NFPA® 72-2013

National Fire Alarm and Signaling Code

TIA Log No. 1188

Reference: Various Sections on Battery

FIGURE A.14.4.3.2 Item 9(d) Example Ohmic Trend Analysis for a 24 Volt Battery Made Up of Two 12 Volt Units.

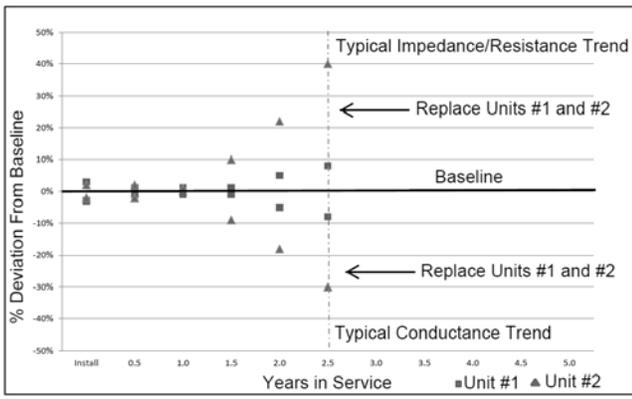
16. Add new A.14.4.3.2 Item 9(d) and associated figure, and A.14.4.3.2 Item 9(e) and associated table to read as follows:

As a battery ages and loses capacity, the internal ohmic values change. Although the change might not be perfectly consistent over all battery models and sizes, experience and extensive test data shows that a deviation of ohmic values from the established baseline by 30 percent or more for conductance and 40 percent or more for resistance or impedance indicates that the actual battery capacity has dropped to 80 percent or lower. (For lead-acid batteries, capacity drops off rapidly once the 80 percent capacity point is reached in the lifetime curve, so this is known as the "knee" of the capacity vs. lifetime curve). This 80 percent capacity is the level at which battery manufacturers recommend battery replacement. Figure A.14.4.3.2 item 9(d) illustrates an ohmic trend of a 5-yr design life battery with an actual expected service life of 3 years. Note that while battery Unit #1 still has good ohmic readings, semiannual measurements show Unit #2 failing prematurely. For this case, it is desirable to replace both units at the same time. If one unit fails at 1-1/2 years, it is likely the second unit will fail in one of the next semiannual tests. Full replacement ensures that all units will "float" together. One exception would be in the case of "infant mortality" in which one of the units fails in the first year.

16. Add the following text, associated figure, and table to Annex A as A.14.4.3.2.Item 9 (d) and A.14.4.3.2 Item 9 (e) as follows:
(Basis: Annex material added to provide the user of this Code adequate explanatory information of newly introduced ohmic testing technology and corrected load test methods, providing user's guidance to ensure these tests are conducting properly. These annex additions are in direct support of the changes to Table 14.4.3.2 recommended by the IEEE Stationary Battery Committee and SIG-TMS Battery Task Group based on published IEEE battery standards and EPRI technical reports. Refer to: IEEE standards 450 and 1188, EPRI technical reports 1002925 and 1006757.)
